UNITED STATES
NUCLEAR REGULATORY COMMISSION
WASHINGTON, D. C. 20555

FROM: Faust Rosa, Chief
Power Systems Branch
Division of Systems Integration, NRR

SUBJECT: AEOD REPORT ON THE LOSS OF OFFSITE POWER EVENT AT
ARKANSAS NUCLEAR ONE, APRIL 7, 1980 (REPORT DATED
OCTOBER 15, 1980)

ARKANSAS POWER & LIGHT COMPANY ARKANSAS NUCLEAR ONE - UNIT 2
Station Single Line Diagram
FIGURE 8.3-1

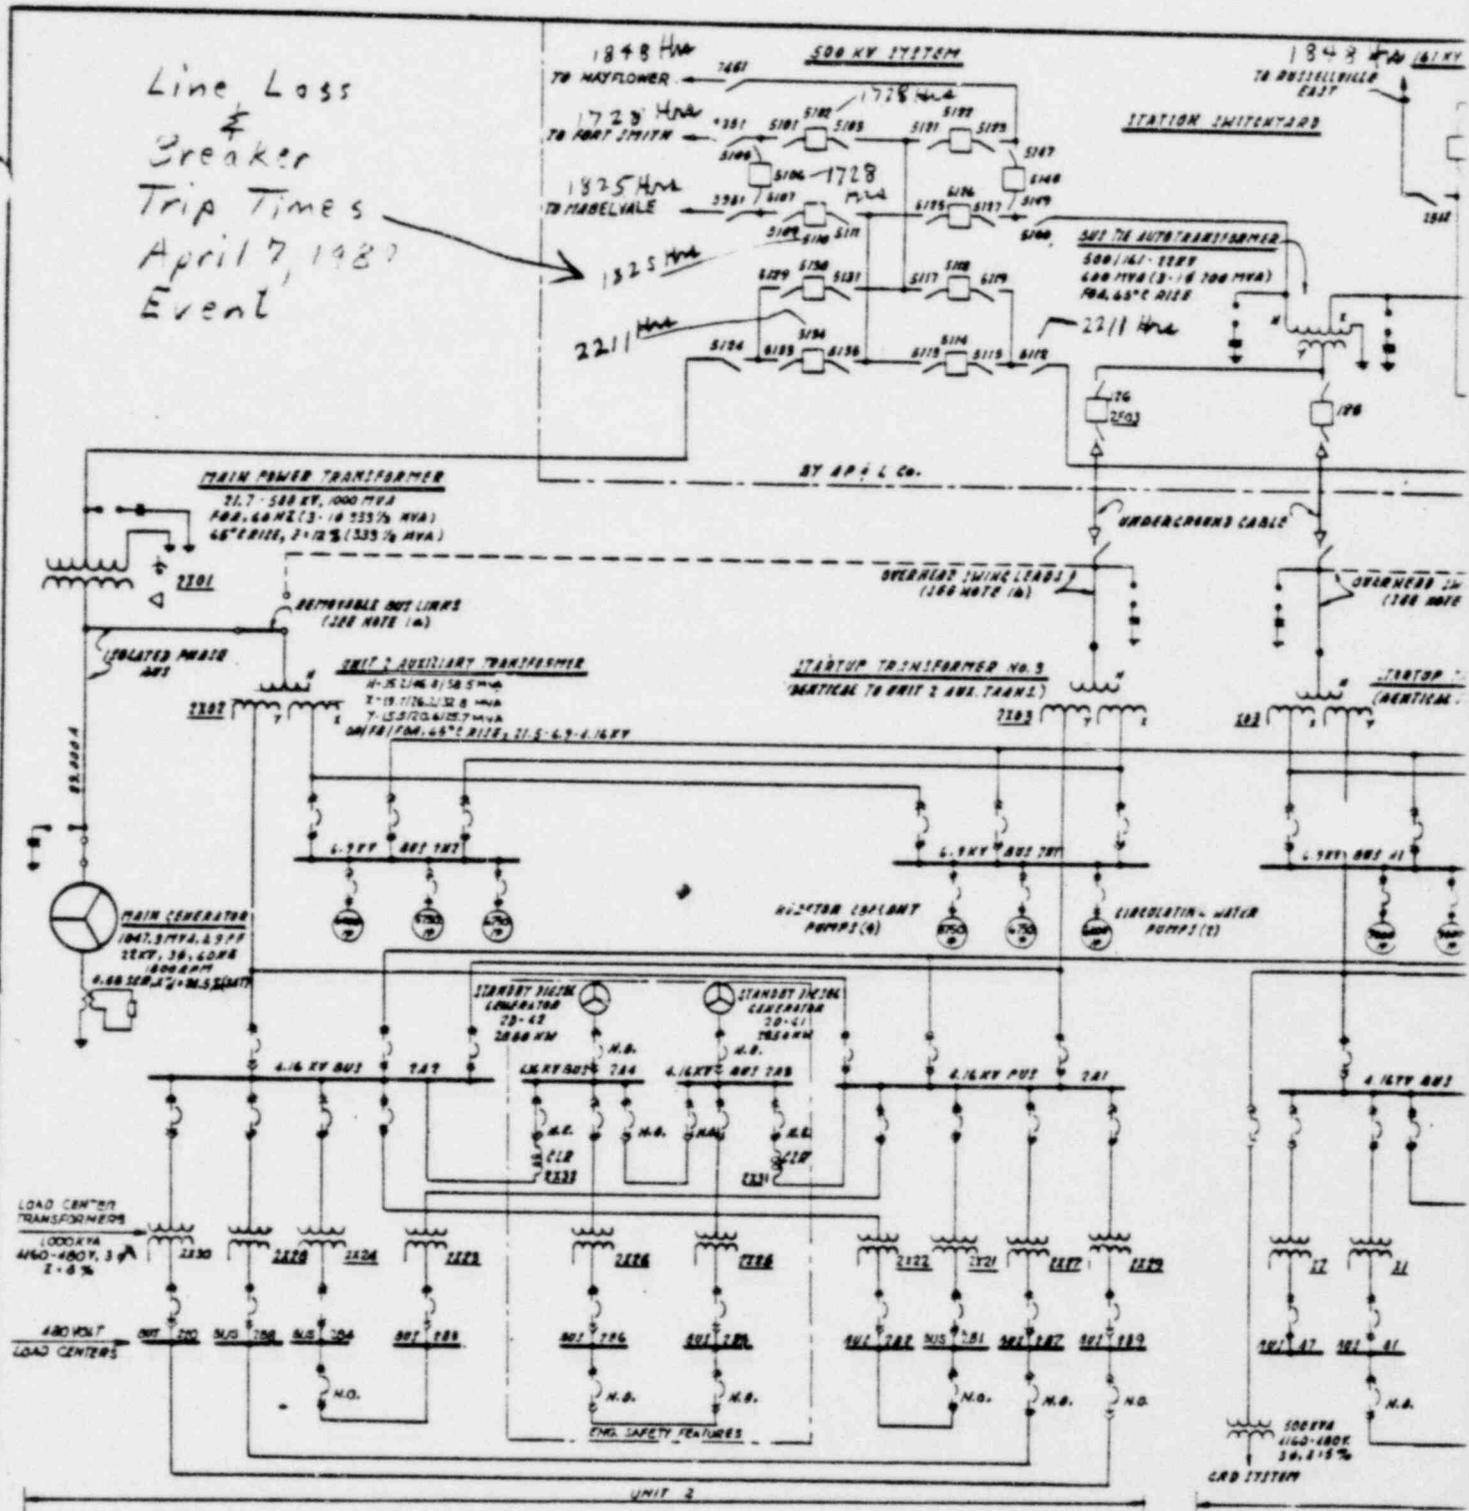
Enclosure 1 provides the interpretation of the requirements of General Design Criterion 17 (GDC 17), Electric Power Systems, and GDC 5, Sharing of Structures Systems and Components, which are used by the Power Systems Branch (PSB) in licensing reviews. Enclosure 2 is the station single line diagram from the ANO Unit 2 FSAR. These enclosures are intended to provide the background for the following specific comments.

5. The AEOD evaluation lacks perspective in that it does not place any emphasis on the remaining capability of the offsite/onsite electric power system immediately following the event. The event was not a total loss of offsite power, only the 500 kv immediate access offsite power capability was lost. The delayed access circuit from the 161 kv switchyard through transformer ST2 to both units was available throughout and could have been used (as noted in the report) by means of manual operator action from the control room. However, operator action to effect this immediately was neither necessary from a safety standpoint or desirable from a human factors standpoint, since the two diesel generators in both units had automatically started and energized all the emergency buses. Additionally, since the 500 kv immediate access circuit suffered no equipment damage, it could have been used as a second delayed access circuit. Thus, on a per unit basis immediately following the event, the onsite system was capable of supplying power for the minimum required accident loads assuming a single failure; and the offsite/onsite system was capable of supplying minimum required safe shutdown loads assuming a triple failure.

6. The subject event involved the failure from offsite causes of four of the five transmission lines emanating from the switchyard. This would be a severe challenge to the offsite system of any multi-unit nuclear plant site, regardless of the specific switchyard/unit circuit configuration. In my opinion, the performance of the ANO offsite/onsite electric power system during the subject event represents an affirmation of the adequacy of GDC 17, not a basis for questioning its adequacy.
